**ED BELL CONSTRUCTION COMPANY**POST OFFICE BOX 540787  
DALLAS, TEXAS 75354-078710605 HARRY HINES  
DALLAS, TEXAS 75220

Mr. James C. Pierce, Jr., P.E.  
Assistant City Engineer  
Town of Addison  
P.O. Box 9010  
Addison, Texas 75001-9010Re: Arapaho Road Reconstruction  
Addison Road to Dallas North Tollway  
Town of Addison

Re: Final Billing

## Sheet P-7

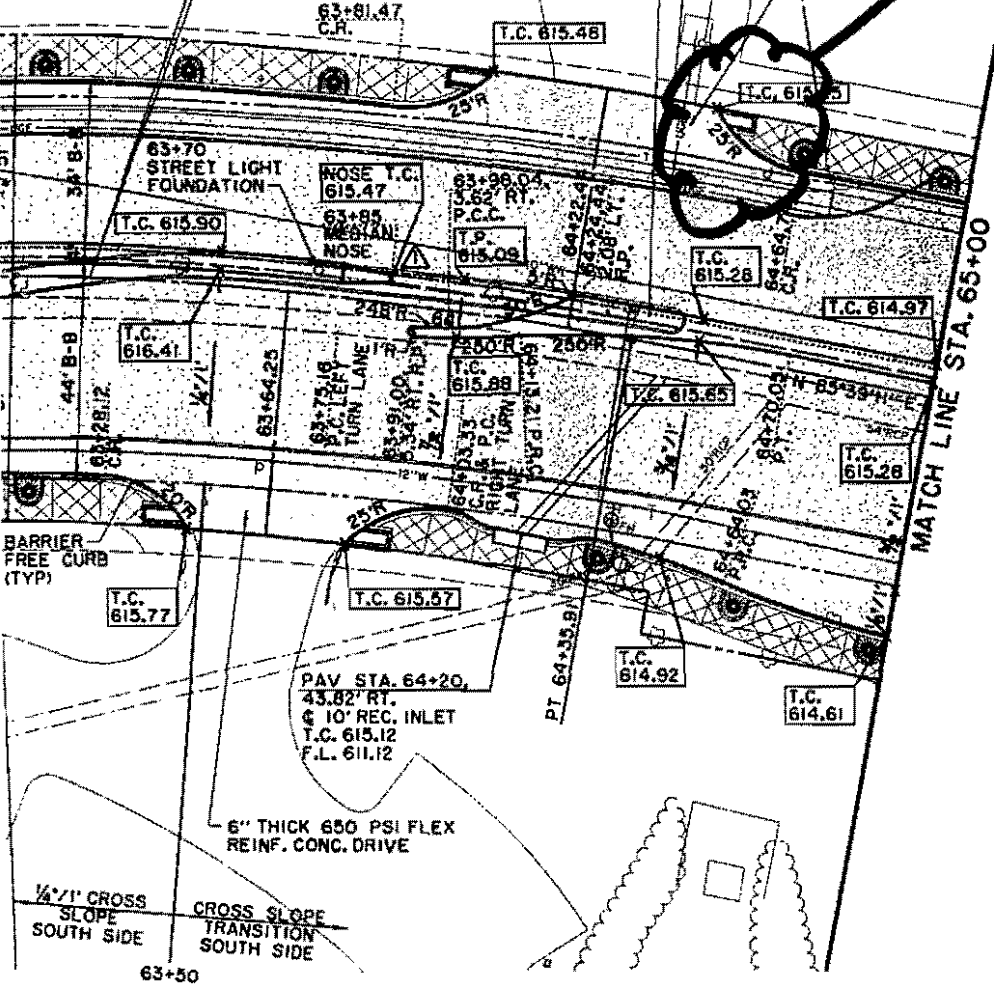
7. The final quantity for Item 111, monolithic median nose, should be sixteen. The additional median nose is located on plan sheet P-7.

COPIES	DATE	NO.	DESCRIPTION
5			Drawing showing new streetlight location & new video camera location.

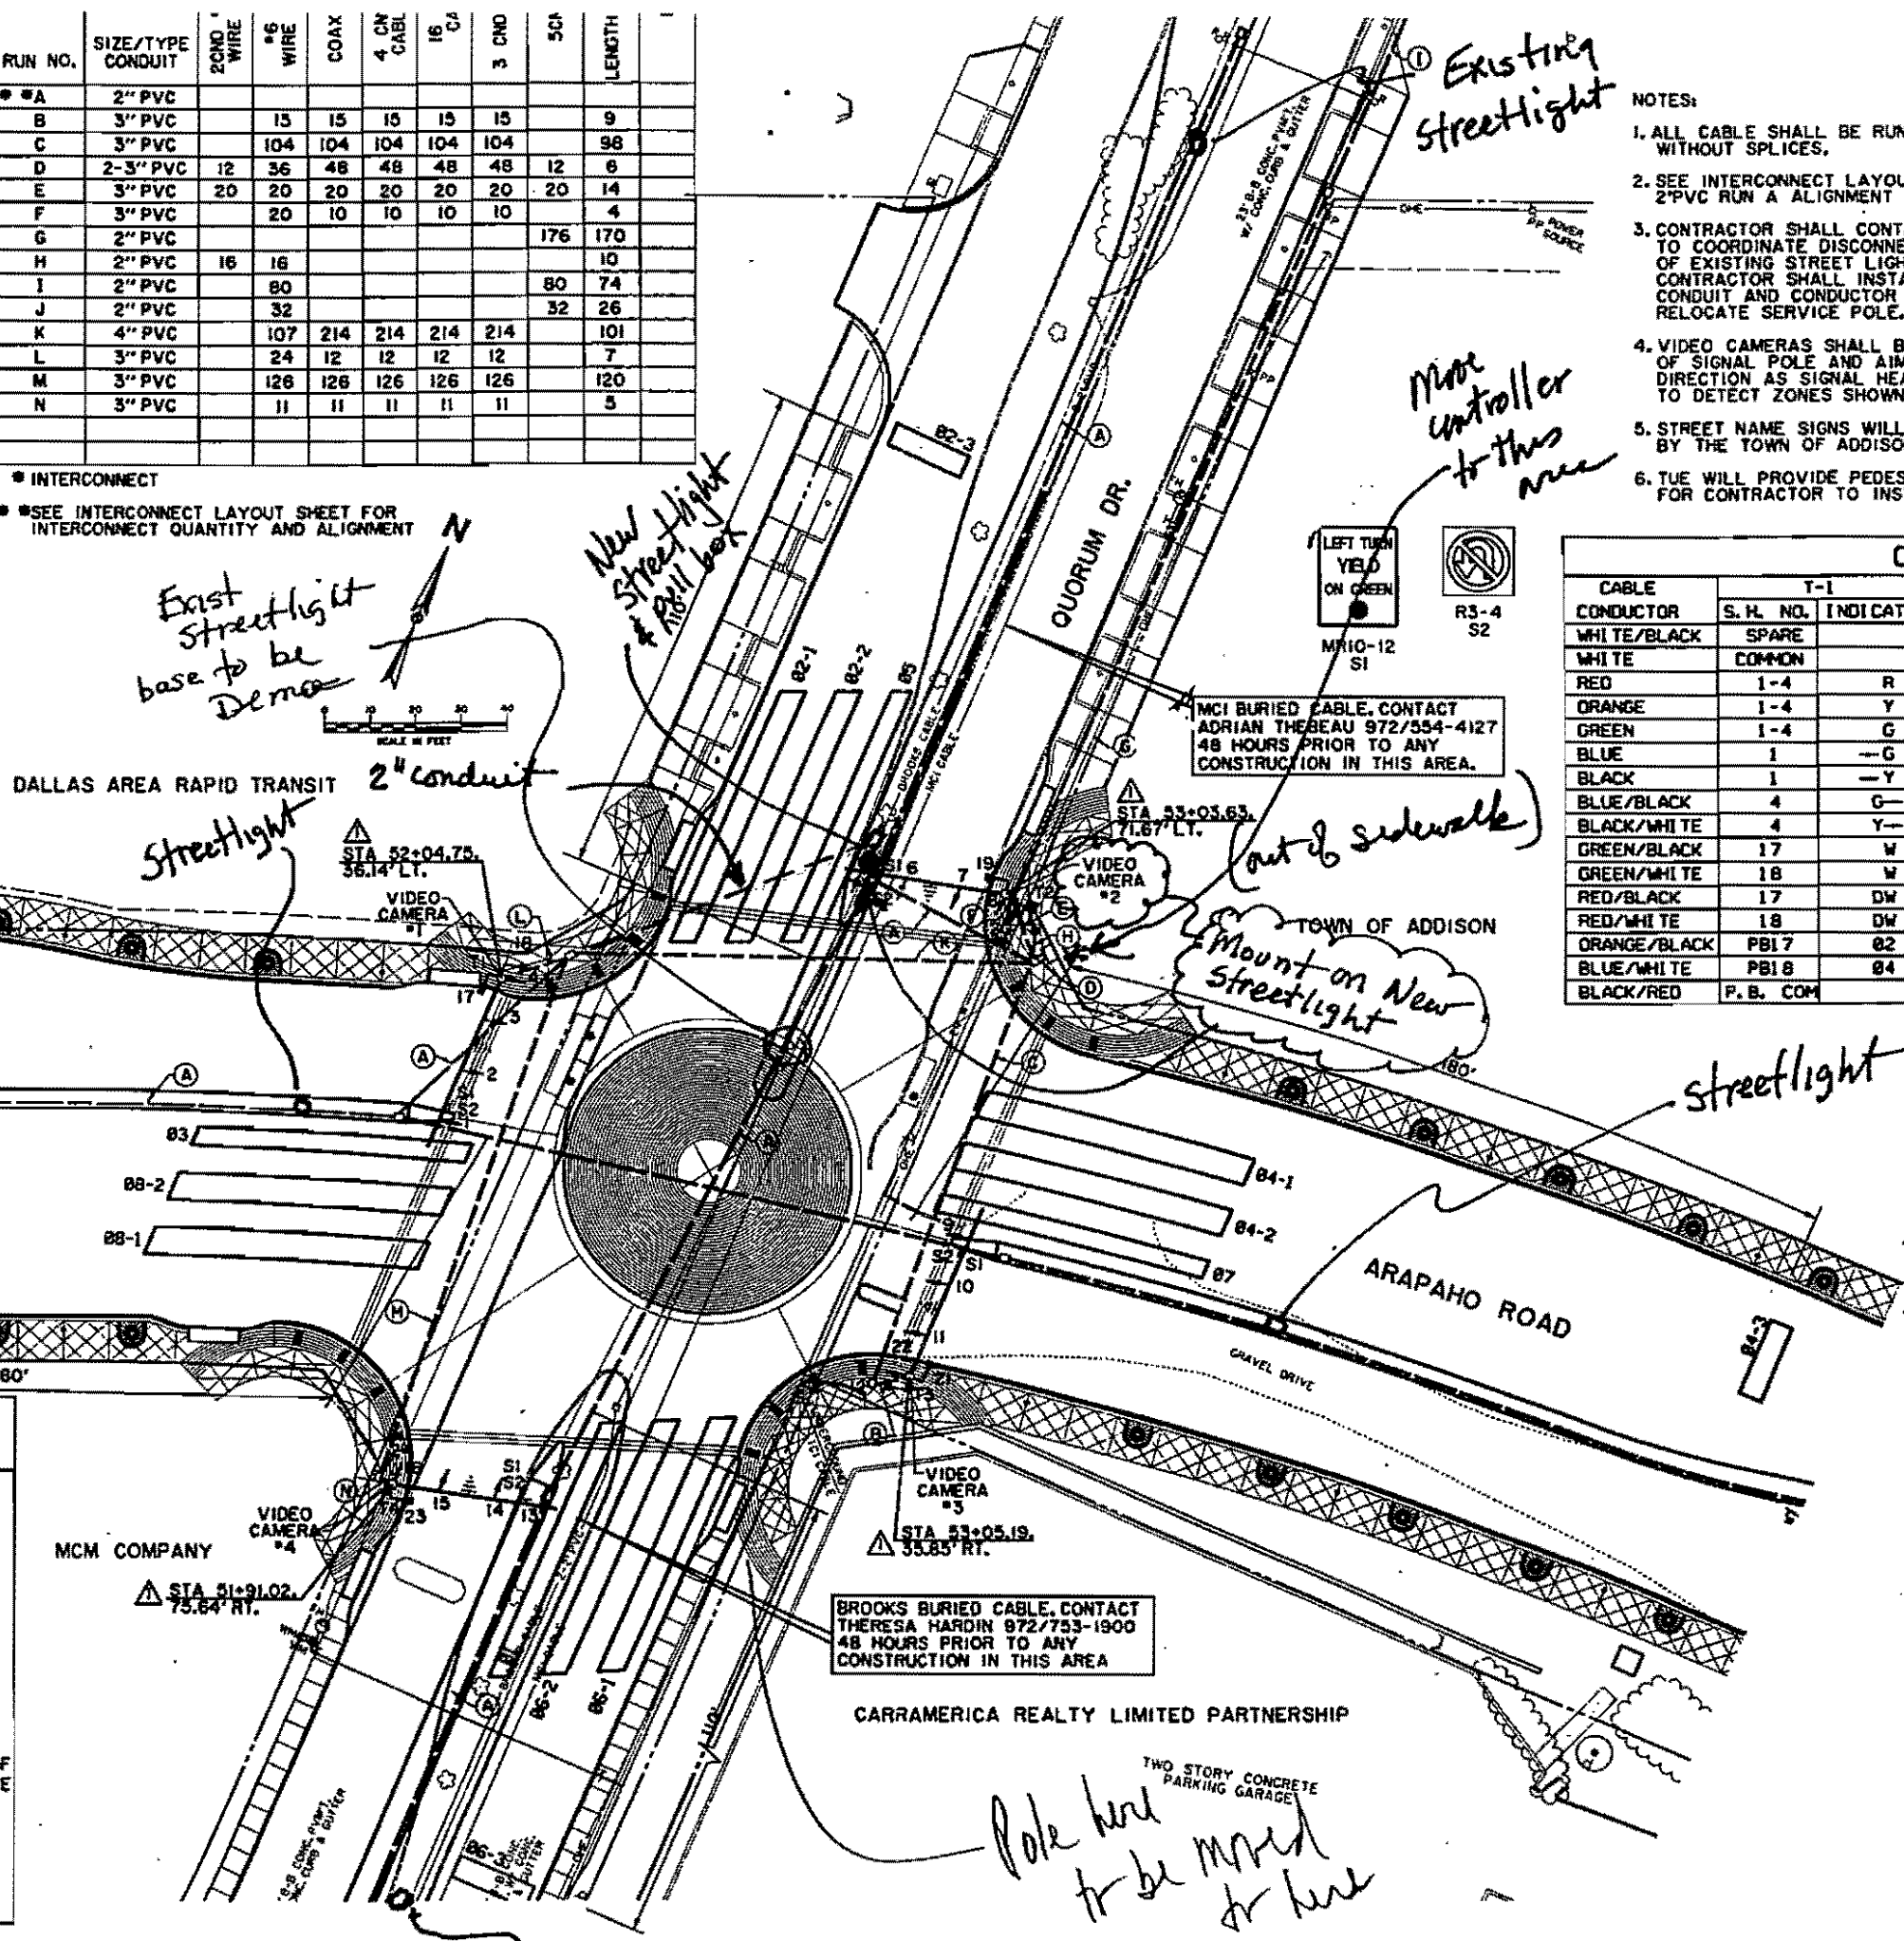
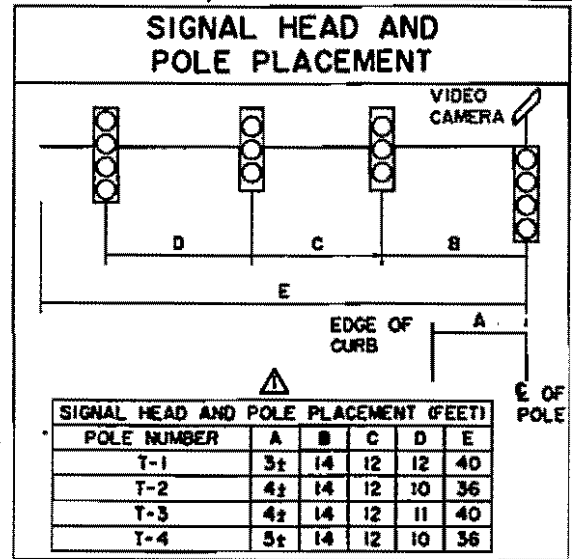
**REMARKS** One of the purposes of the new streetlight location is to provide a better mounting location for the video camera. We should have existing pay items for this work except for conduit up the streetlight for mounting the camera. Please incorporate this change into the work and advise of any additional charges.

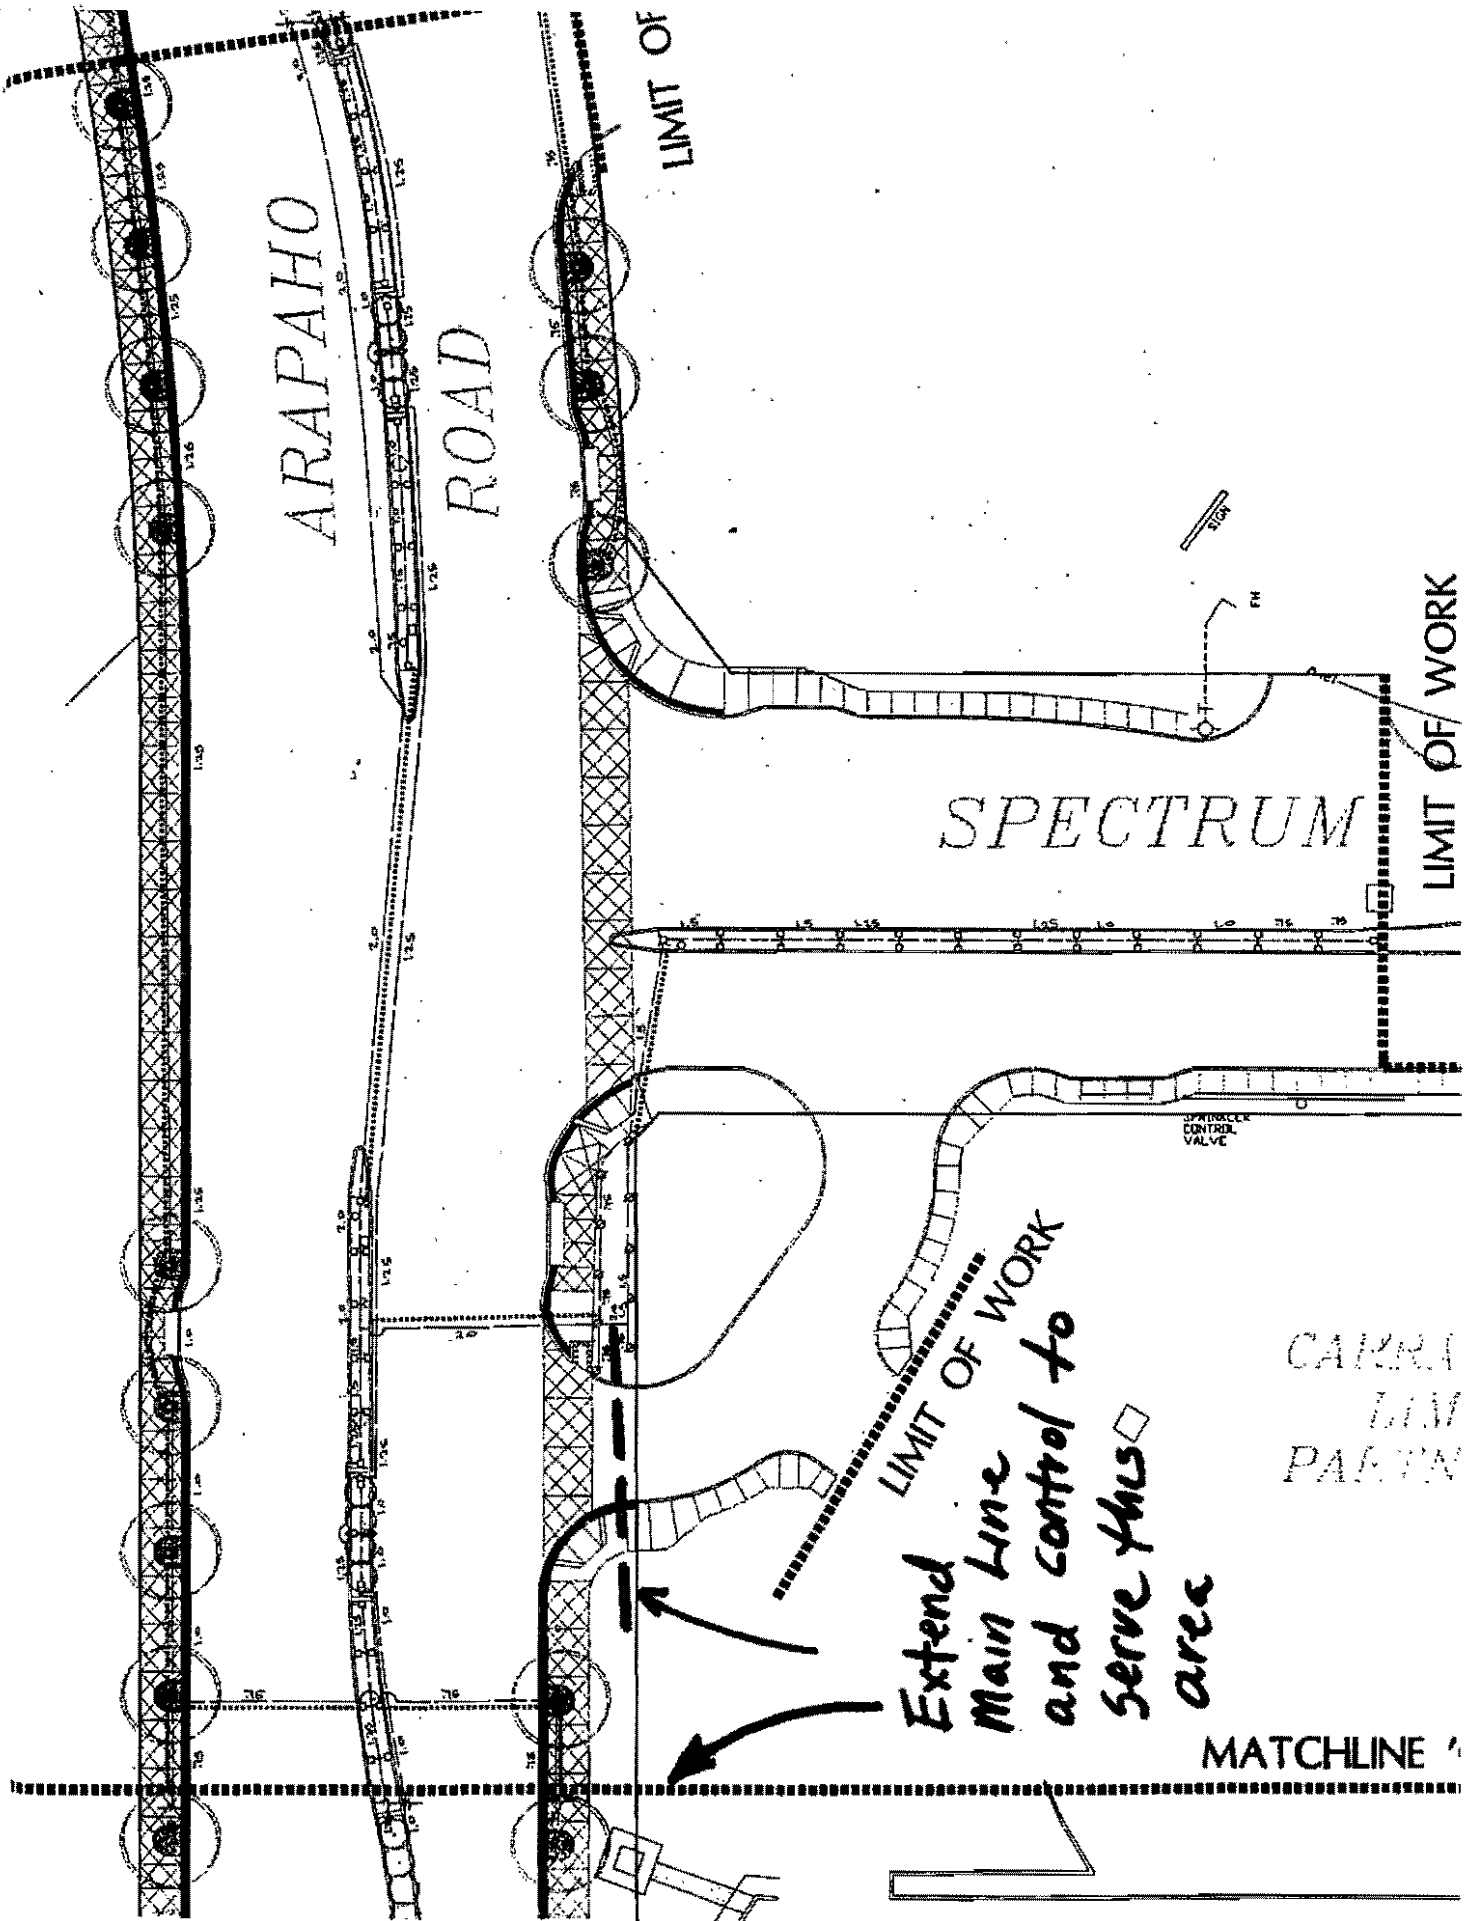
The area adjacent to the CarAmerica brick wall is NOT served by irrigation. Item 404 can be used to bore under driveway. We are requesting Irritech to lay out an irrigation system for the area. The intention is to pay for this by extension of quantities.

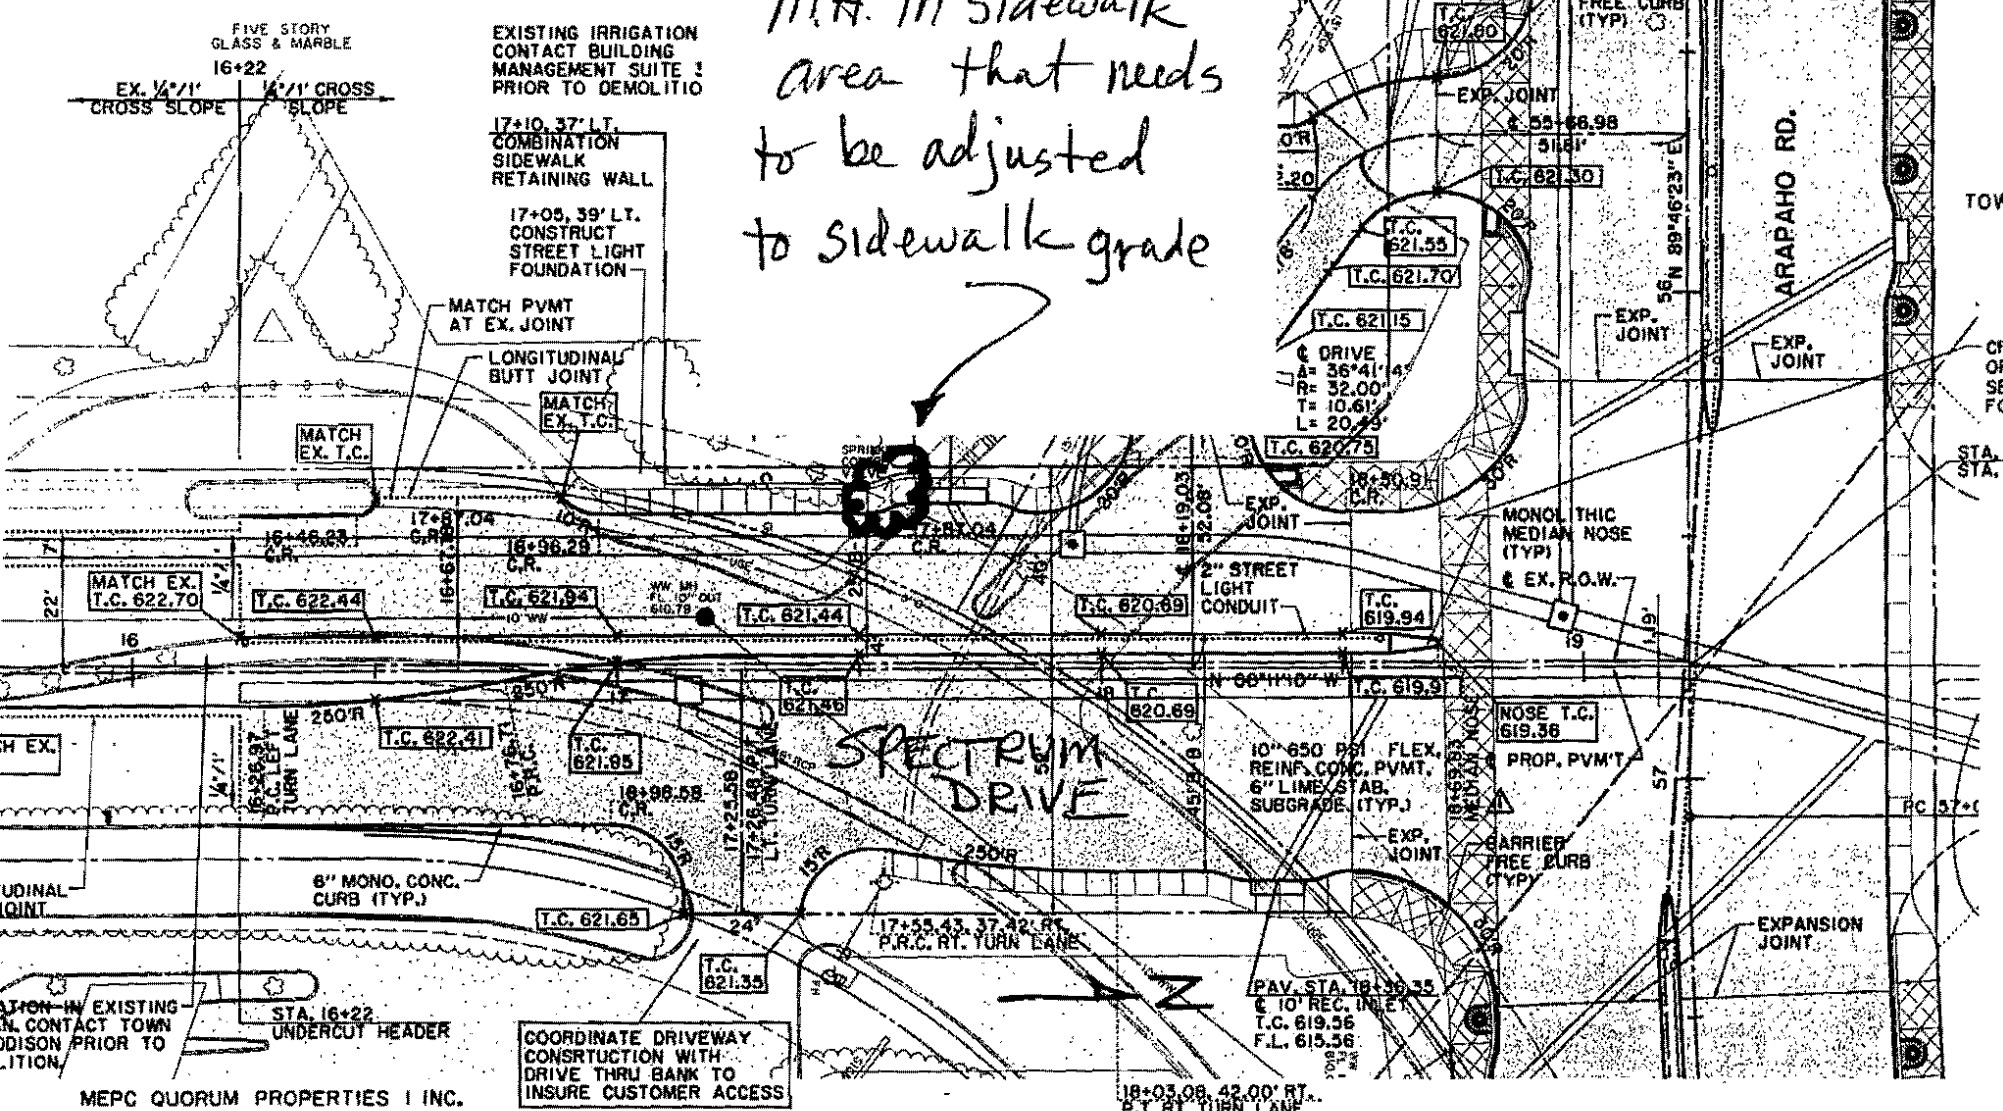
Comments: The attached sketch shows  
the location of a manhole (services  
Carri America) that needs to be raised  
up to our sidewalk grade. Sidewalk  
is under const. now. Can you  
get it raised up or outsource our  
contractor to do so? please call

Location of M.H. in sidewalk area that needs to be adjusted to sidewalk grade

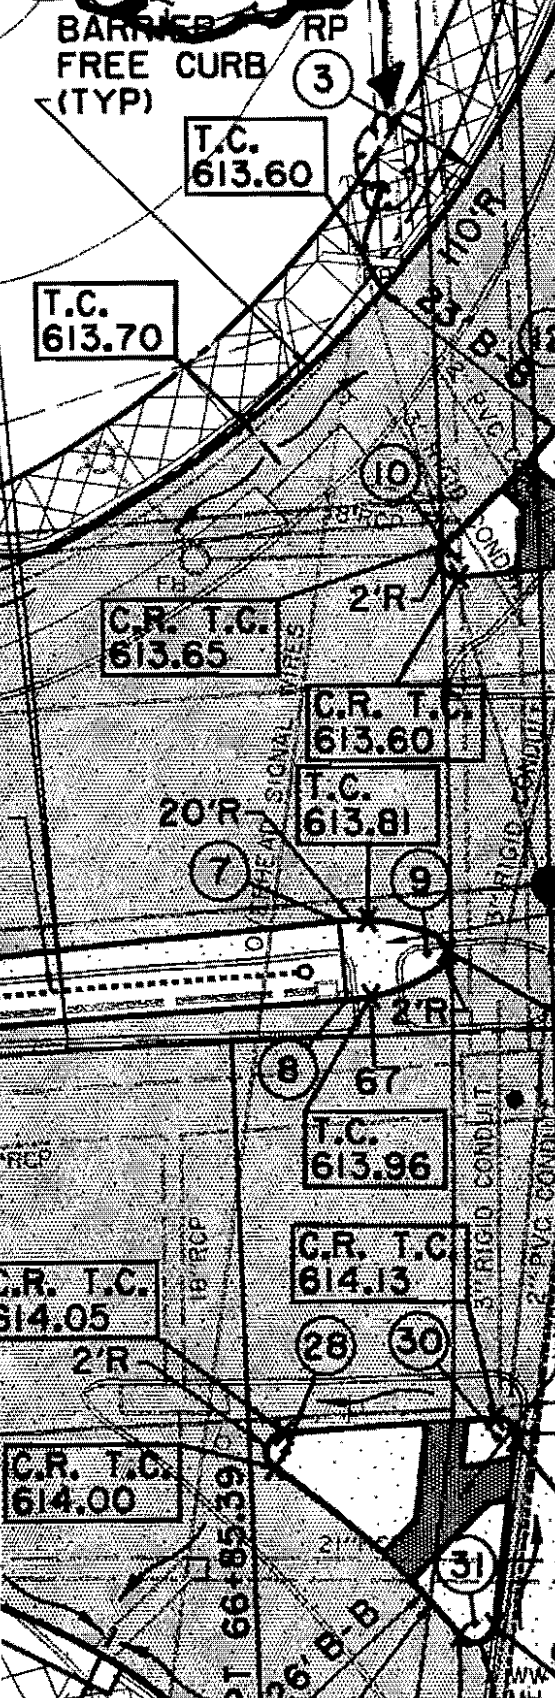
Comments: The attached drawing shows a  
signal pole guy wire located in our  
sidewalk area. Can this guy wire  
be moved? We have it "blocked out"  
right now. Please advise. Jim
